R44

SERVICE BULLETIN SB-23

SUBJECT: Replacement of C018-1 Clutch Assembly

ROTORCRAFT AFFECTED: R44 Helicopters S/N 0001 through 0322 excluding S/N 0182, 0224, 0228, 0253, 0301, 0306, 0307, 0311, 0312, 0314, and 0319.

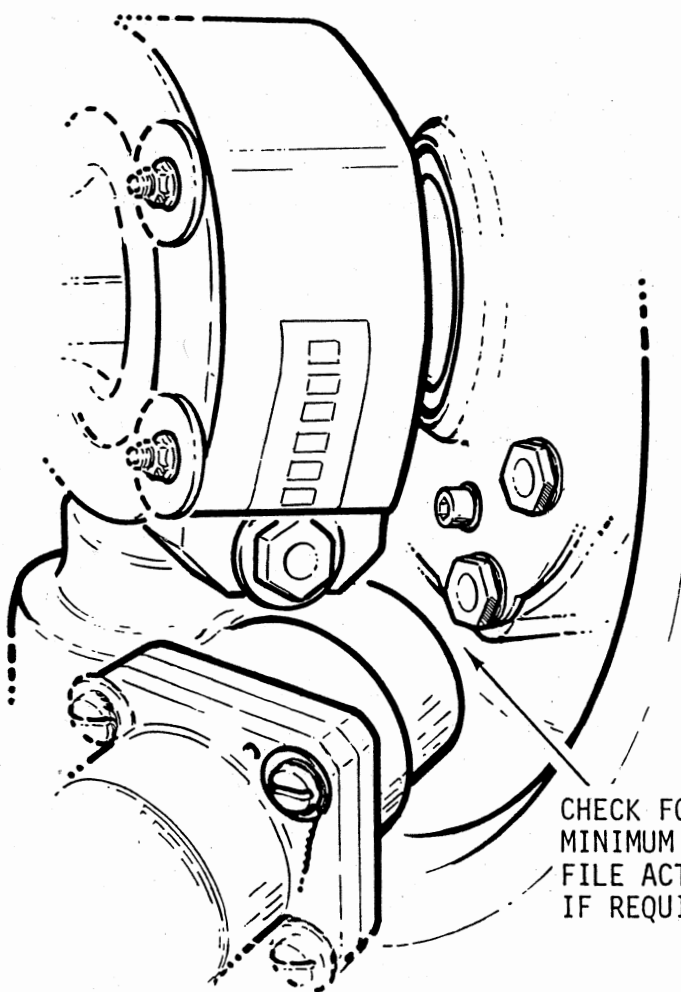
8. Rotate upper sheave to obtain minimum clearance between sheave bolts and actuator gear housing per figure on page 2. Engage clutch switch to fully tension V-belts. Check for 0.06 inch minimum clearance between bolts and housing. Housing may be filed to provide clearance if required.

CHECK FOR 0.06 INCH  
MINIMUM CLEARANCE.  
FILE ACTUATOR HOUSING  
IF REQUIRED.
